**WARRANTY  
 BULLETIN**

Wb07-01

<b>DATE :</b> MAY 2007	<b>SECTION :</b> 16 - Suspension
<b>EXPIRATION:</b> MAY 2009	
<b>SUBJECT :</b> RETAINING RING INSTALLATION ONTO FRONT SUSPENSION SWAY BAR

FIGURE 1

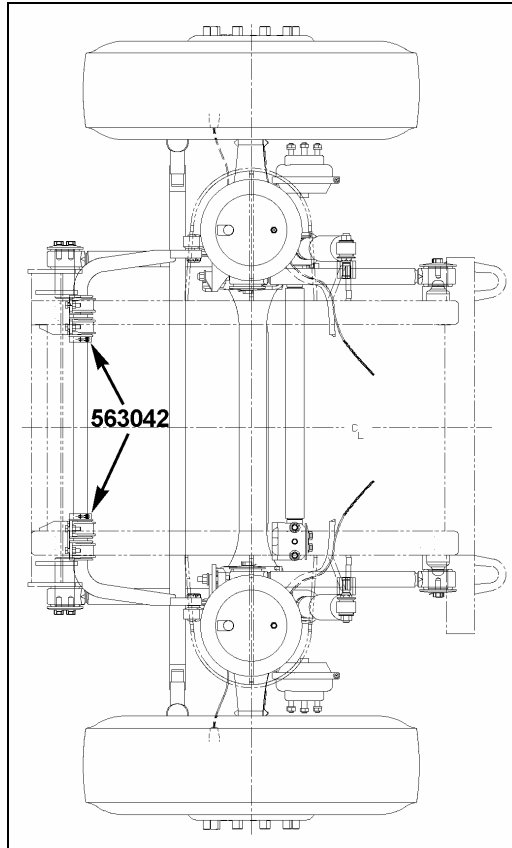
Check if the retaining rings were installed onto the vehicle front sway bar (Refer to figures 1 and 2).

Two retaining rings are required, one on each clamp collar side towards the center of vehicle

1. Center sway bar with reference to clamp collars.
2. Install retaining rings. Apply some "Loctite" 243 blue onto the retaining ring bolt threads.

FIGURE 3

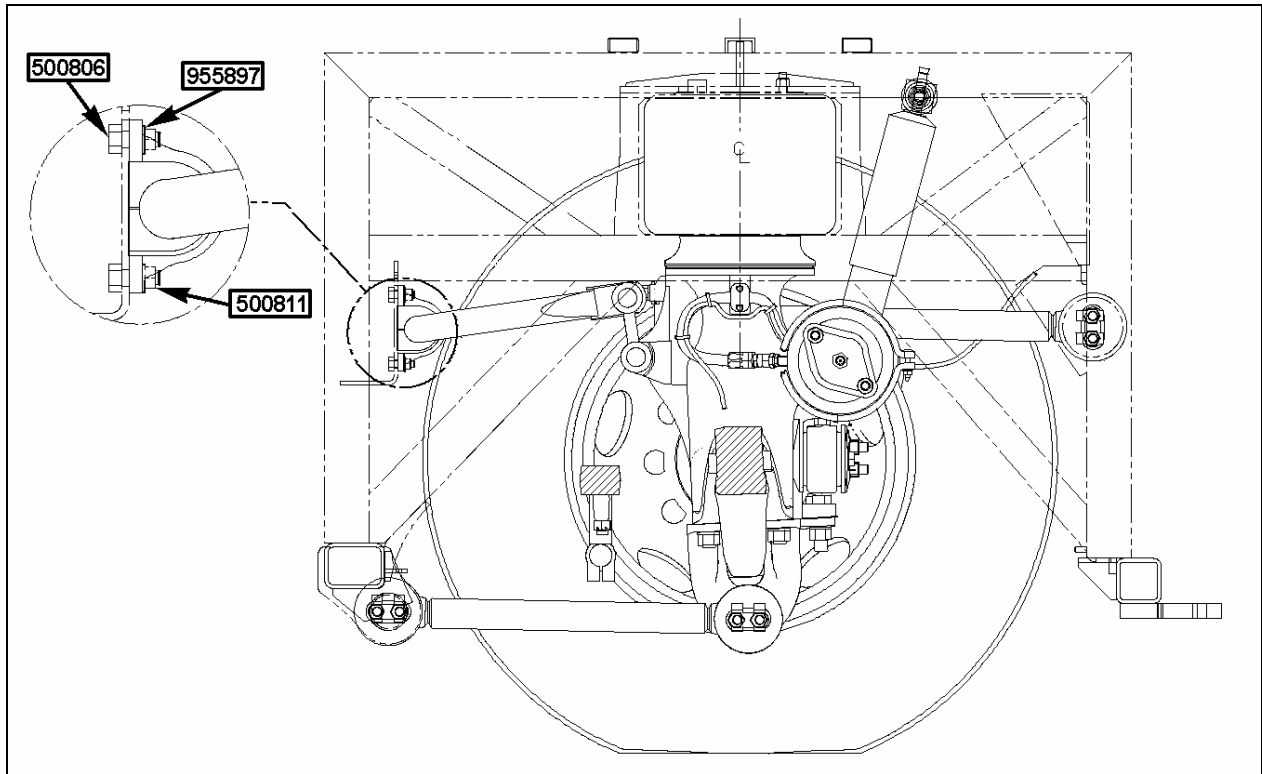
If you have difficulty centering the sway bar, it is necessary to withdraw the clamp collars then to reinstall them after centering the sway bar using new bolts (500806), washers (955897) and nuts (500811). Reapply "Valvoline" (Refer to figure 3).
